MARTIN COUNTY, FLORIDA DEVELOPMENT REVIEW

STAFF REPORT

HOBE SOUND TOWNHOMES MINOR FINAL SITE PLAN

Attachment I – Sketch and Legal Redlines

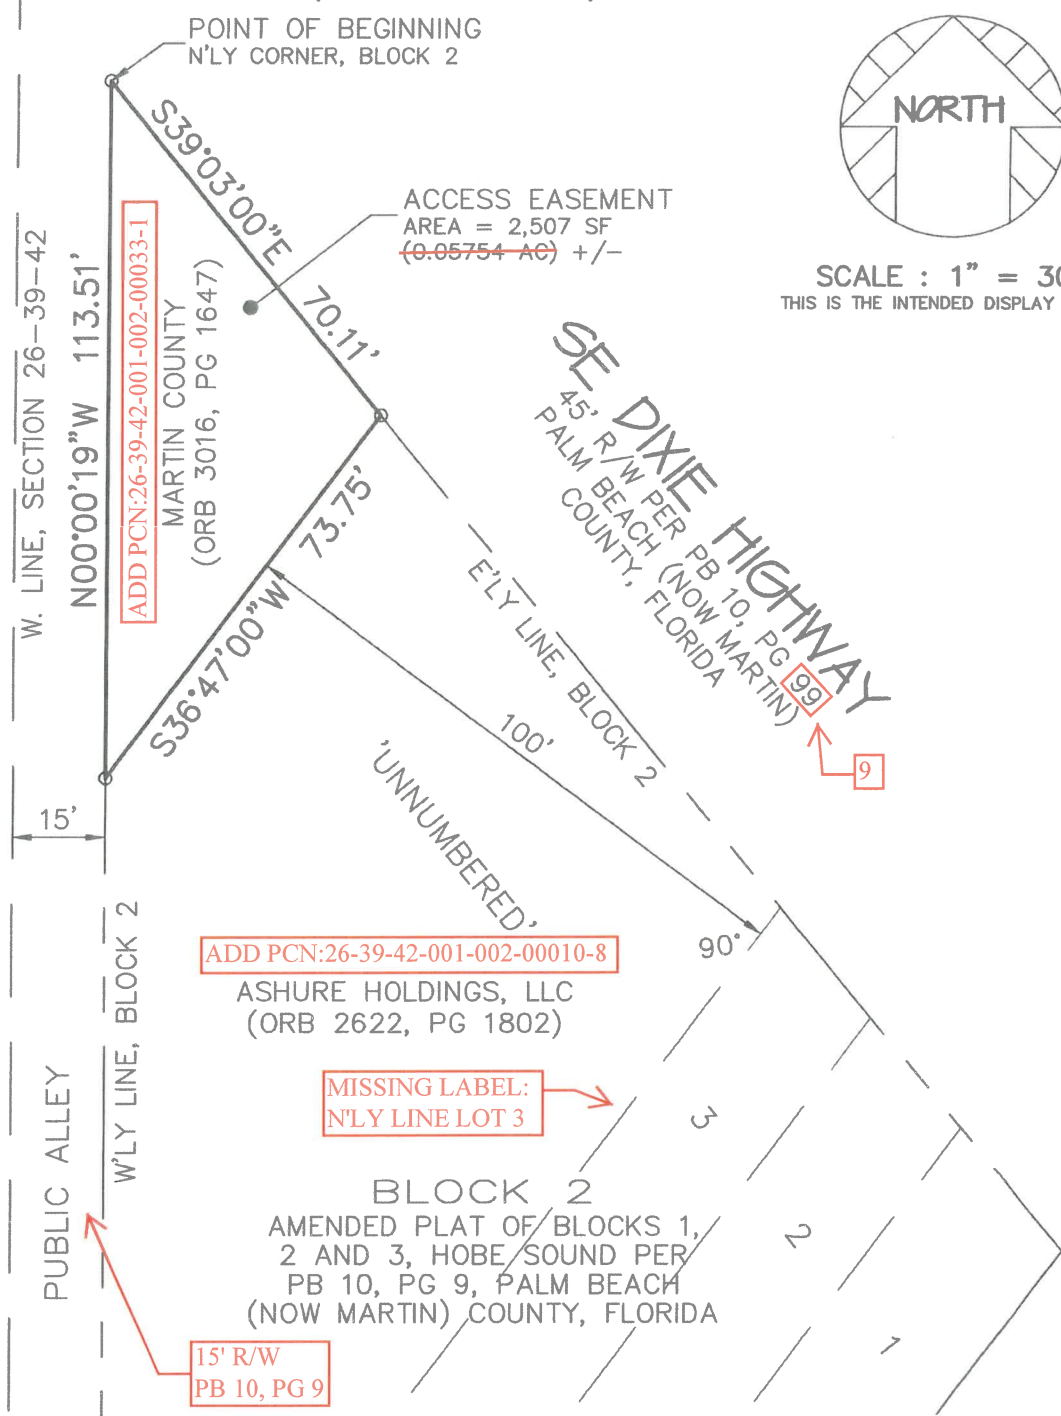
PLEASE SEE COMMENT NOTATIONS.

~~ACCESS-EASEMENT~~ RIGHT OF WAY

CONTAINING 2,507 SQUARE FEET (~~0.05754 ACRES~~) MORE OR LESS.
